Date: November 29, 2018 Time: 7:00 p.m. Location: Santa Margarita Community Room
2 Civic Center Drive, Scotts Valley, CA 95066

Santa Margarita Groundwater Model Evaluation to Support Groundwater Sustainability Plan Development (EKI B80057.00)

Santa Margarita Groundwater Model
Evaluation to Support Groundwater Sustainability Plan Development
September 12, 2018

Extents of the SMGWM and the SCMCM. Areas of Santa Margarita Basin in which the SMGWM are not modeled are shown in red.

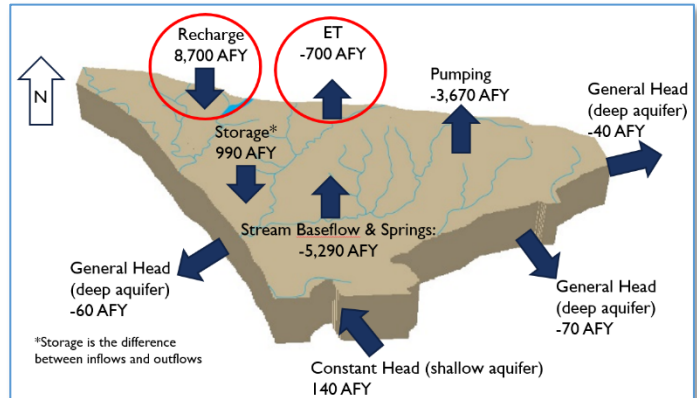
The SGMA requires that the model encompass the entire basin and consistency between cross-boundary/basin flows. Our evaluation of the geohydrologic framework concluded that the model grid needs to be expanded to overlap the mapped basin boundaries (no change is recommended to model cell dimensions or layering) and the vertical hydraulic conductivity of the modeled aquifers should be adjusted to better match reported aquifer test results. The grid expansion should consider including the San Lorenzo River and associated alluvial areas outside the defined basin boundaries, which likely can improve comparisons between model calculated and reported baseflows. The Santa Cruz Mid-County Basin Model (SCMCM) is the only adjacent existing model, and the cross-boundary flows between the two models are fairly small (on the order of 100's of acre-feet per year [AFY]) and appear to be opposite in direction. This discrepancy can likely be resolved as part of the model grid expansion and re-calibration.

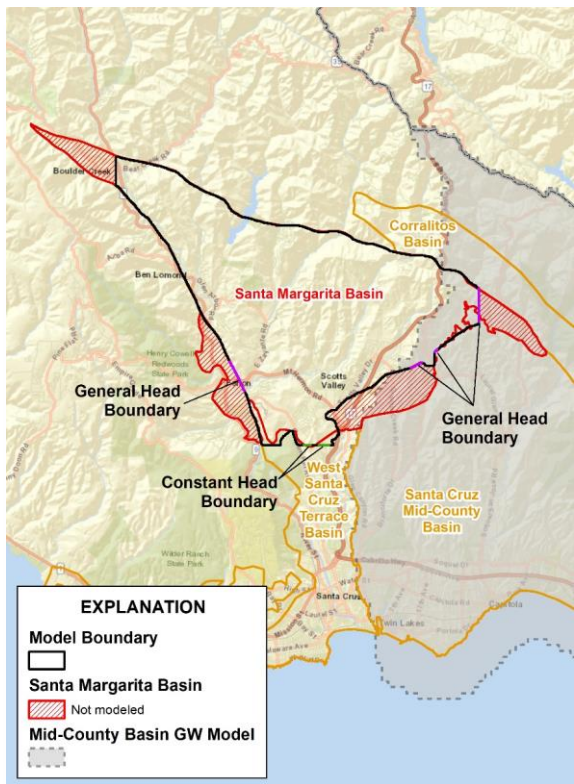
- Partial over-lap with Mid-County Basin Model; General Head along SE boundary (layer 7 only).
- Constant Head along interface with West Santa Cruz Terrace Basin (layer 1 only).
- SW general Head along part of Ben Lomond fault (layer 7 only).

SGMA requires that (1) the model encompass the entire basin; and, (2) cross boundary flows between adjacent models are consistent. The Santa Margarita Groundwater Model (SMGWM) does not cover the entire Santa Margarita Groundwater Basin as defined by DWR. Expanding the model grid to cover some areas likely provides little benefit to model reliability because the areas have little significance in regards to recharge and groundwater use. In contrast, the San Lorenzo River is a significant hydrologic feature, and it meanders across portions of the western basin boundary defined by DWR, effectively excluding parts of the river and associated alluvial areas from consideration in basin calculations. This should be considered when developing future plans to modify model boundaries.

SANTA MARGARITA AQUIFER (LAYER 1): 14 DIFFERENT HORIZONTAL CONDUCTIVITY ZONES, AND VALUES ARE AT THE LOW END OF THE RANGE FROM AQUIFER TESTS

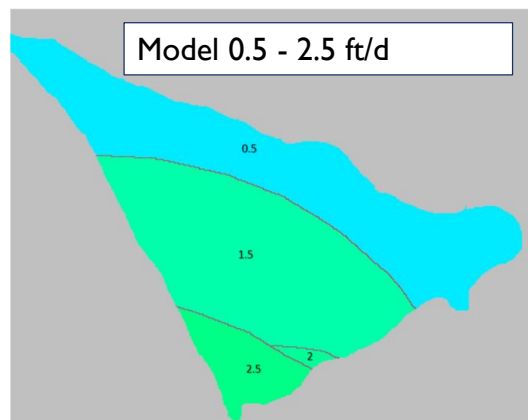
Observation well locations provide limited support for zones.

LOWER BUTANO FORMATION (LAYER 7) HORIZONTAL CONDUCTIVITY VALUES ARE AT THE LOW END OF THE RANGE FROM AQUIFER TESTS

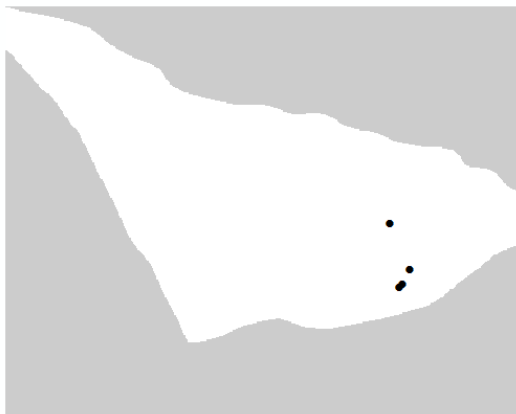
Reported transmissivity values for the Butano range from 177 to 1,637 ft²/d (0.2 – 1.6 ft/d K assuming 1,000 ft layer 7 thickness)

There are only a handful of observation wells available to represent conditions in the Lower Butano formation (layer 7). The horizontal hydraulic conductivity of model layer 7 (Lower Butano) is represented by a single conductivity zone, and is consistent with this limited spatial distribution of observation wells for characterizing conditions in layer 7. The modeled horizontal hydraulic conductivity value (0.25 ft/d) is similar to the lowest values estimated from reported aquifer test results (Appendix D from 2015 model report).

ET = 700 AFY (8% OF RECHARGE)

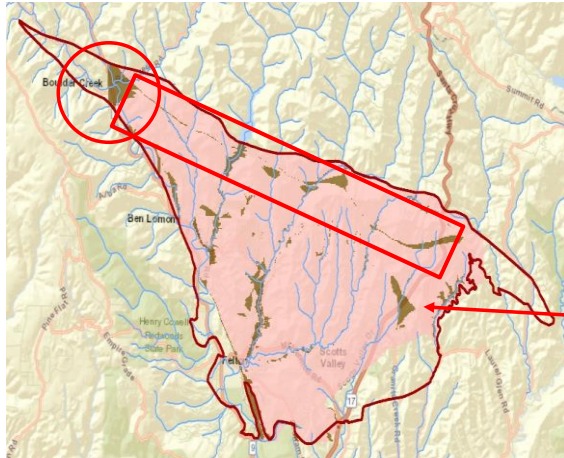
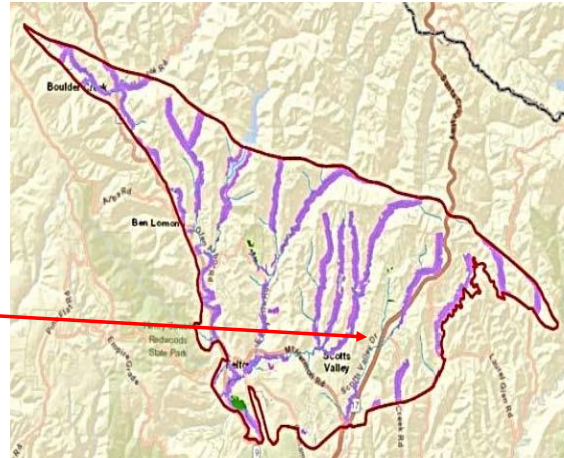
The SMGWM employs the MODFLOW ET package to simulate plant consumption of shallow groundwater. Model input files are specified so that model calculated ET can occur across the entire basin, and therefore ET is a function of model-calculated depth to water rather than the known presence of plants that utilize shallow groundwater.

Inspection of model results provides evidence that the ET calculations by the groundwater model might be unwarranted. The map on the left shows model cells that simulate ET during stress period 40 (a time period of low rainfall and relatively deep water table conditions), which presumably represents the minimum areal distribution of model calculated ET; most other time periods have greater recharge and presumably larger simulated areas where ET is calculated by the SMGWM. The map on the right shows the distribution of iGDEs as identified by the Nature Conservancy in conjunction with DWR (groundwaterresourceshub.org and gis.water.ca.gov/app/NCDatasetViewer/). Comparisons between the two maps show reasonable agreement in some areas, and limited to no correspondence in others. For

example, the model results indicate shallow groundwater conditions over an unrealistically large area near the northwestern model boundary and large area northwest of Scotts Valley. Additionally, there is a narrow band of ET simulated across the basin that appears to be an artifact of internal model boundaries and parameterization rather than real-world hydrologic conditions. Moreover, because the recharge calculations consider plant water consumption as part of its calculations, utilizing the ET package to simulate additional water consumption by plants in these areas seems to double-count plant water use. The implementation of the ET package in the SMGWM could be restricted to known areas where plants rely on shallow groundwater for their water needs, if there are any, and recharge calculations and model-calculated discharges (e.g., ET) could be modified for these areas to prevent double counting of water use and characterize the sensitivity of groundwater flow to GDEs to changes in groundwater storage.

SITE 1: REASONABLE AGREEMENT IN MAGNITUDE AND TREND

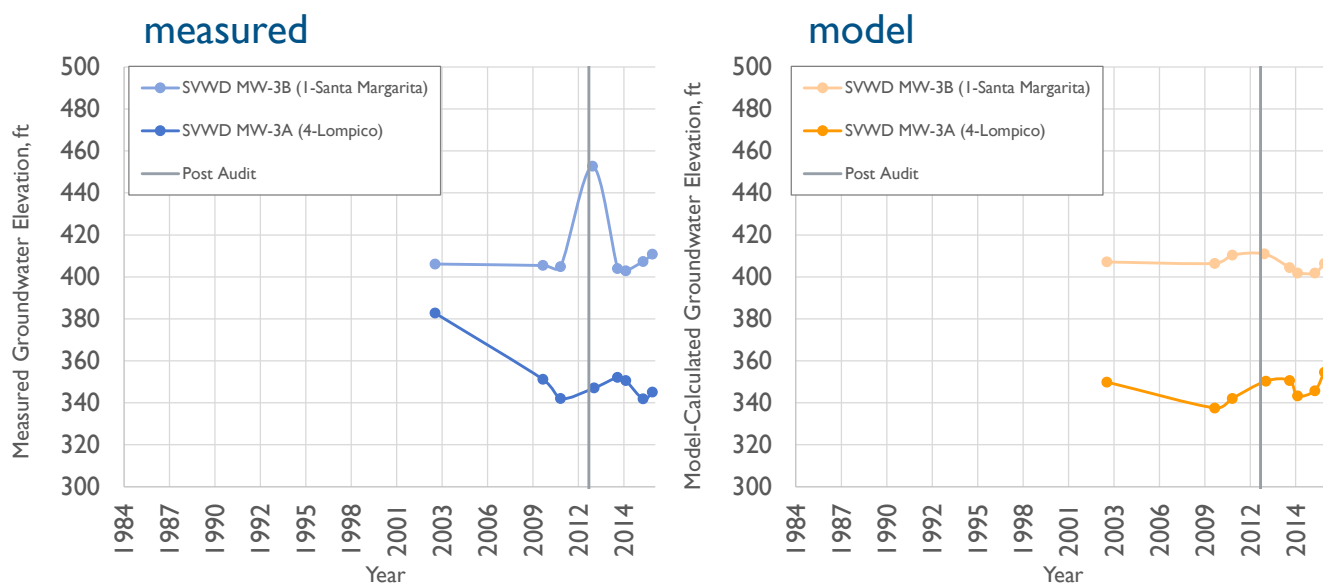
Site 1: measured and model-calculated water levels generally agree in magnitude and temporal trend. A notable exception is the 2012 measurement for the Santa Margarita; the 195 feet water level rise between January and October 2012 is suspicious, and not reproduced in the model results. This discrepancy between measured and model-calculated water levels can be attributed to data errors in the field (data recording error) or in the model (data entry error when translating the observations to MODFLOW).

SITE 2: TRENDS AGREE BUT NOT MAGNITUDES.

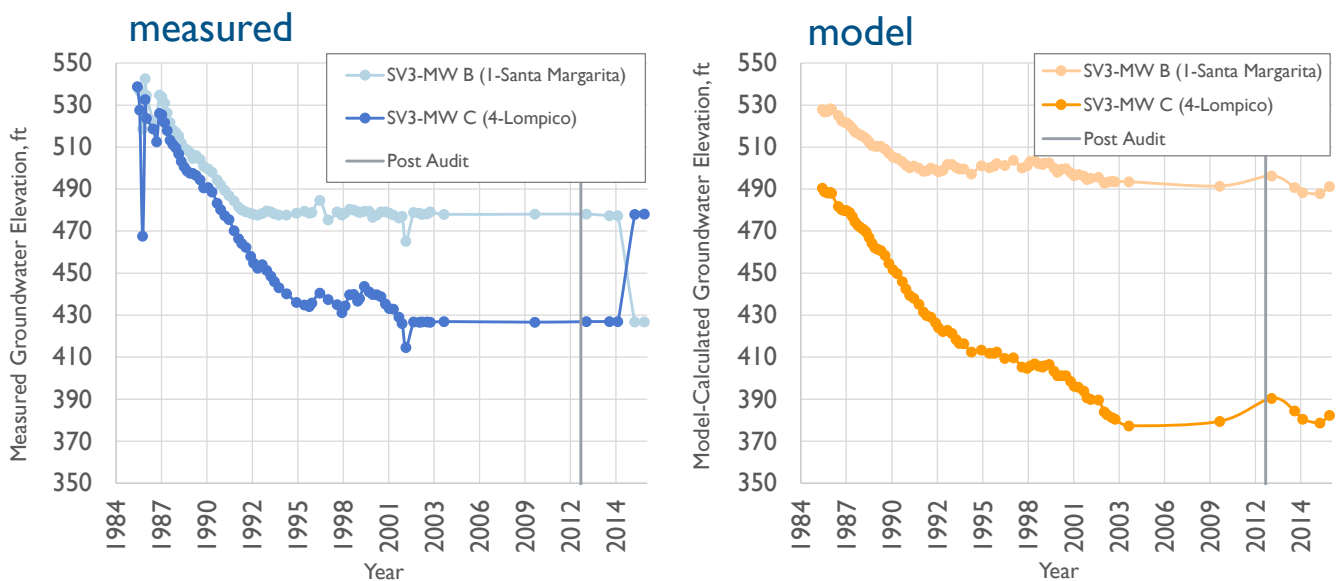
Site 2: model-calculated and measured water levels decline and stabilize. In the Santa Margarita, water levels decline during the period 1985 to about 1992, however the model-calculated decline of about 30-feet (light orange) is less than measured (the light blue plot showing a decline of about 60-feet). In the Lompico, model-calculated and measured water levels both decline about 100-feet during the period 1985 to about 2003. The model-calculated water level in the Lompico (dark orange) is about 50 feet lower than measured (dark blue), and as a result the model-calculated difference between water levels in the Santa Margarita and Lompico is greater than measured.

Note that the last two data points in the graph on the left (the measured values) appear to be switched, suggesting either data entry errors in the field or model input errors when transferring the measurements to MODFLOW.

SITE 5: MAGNITUDES AND RELATIVE DIFFERENCES BETWEEN DEPTHS DO NOT AGREE.

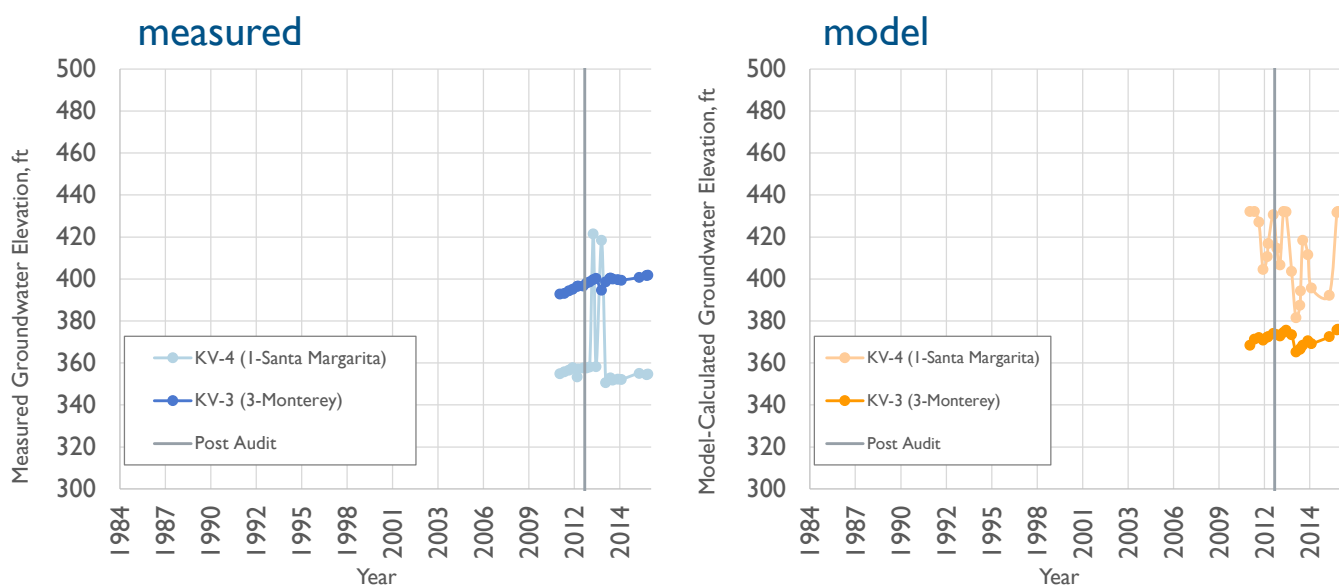
Site 5: in the Santa Margarita Aquifer, the measured water levels (light blue) and model-calculated water levels (light orange) do not show a clear trend, and the model-calculated water levels show much more temporal variability. The model-calculated water levels are also about 40 feet greater than measured. The sudden measured 60-foot water level rise represented by two data points is suspicious and may indicate measurement, reporting, or data entry error. The deeper well is screened in the Monterey (model layer 3); the measured water levels (dark blue) are about 20 feet greater than calculated by the model (dark orange), but the measured and model-calculated trends are generally similar. The measured values indicate the water levels in the Santa Margarita are lower than in the underlying Monterey. In contrast, the model-calculated water levels indicate that the water levels in the Santa Margarita are greater than in the underlying Monterey. The relative differences in measured and model-calculated water levels between depths are therefore reversed.

SITE 8: TREND AND MAGNITUDE DO NOT AGREE

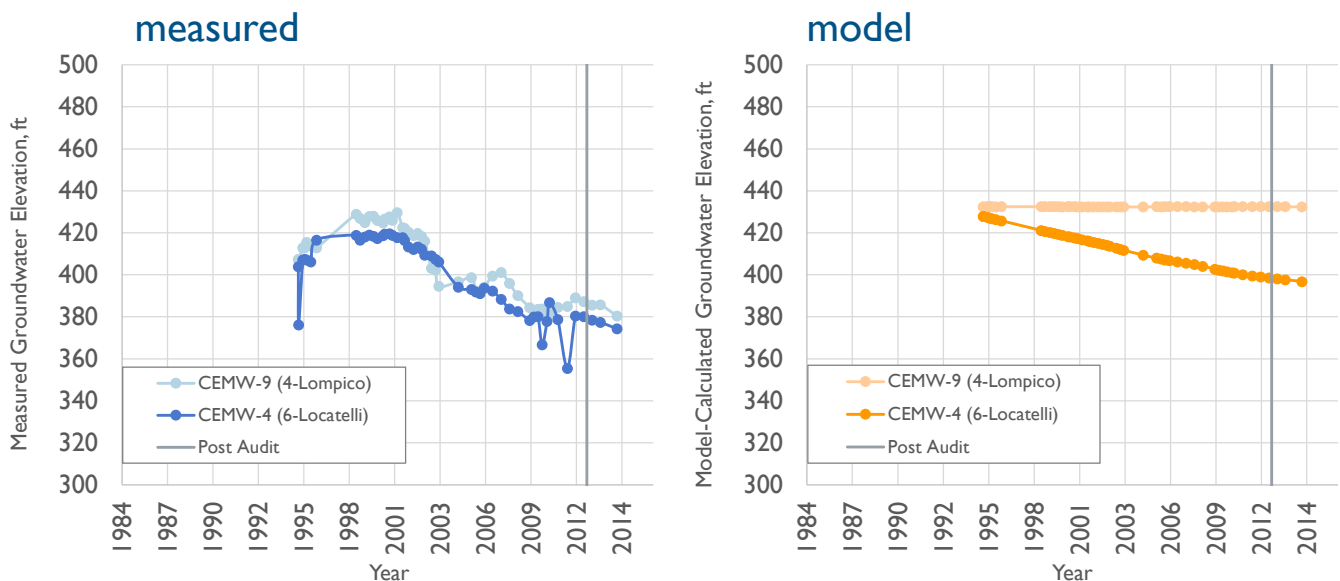
Site 8: the magnitude and trend in measured water levels are similar in the Lompico and Locatelli aquifers, whereas the magnitude and trend in model-calculated water levels are different in the two aquifers. There is no model-calculated trend in the Lompico Aquifer, and the declining trend in the Locatelli Aquifer is less steep than measured. The model-calculated water levels in the Lompico Aquifer (light orange) are 10 to 50 feet greater than measured (light blue), and in the Locatelli the model-calculated water levels (dark orange) are 10 to 20 feet greater than measured (dark blue).
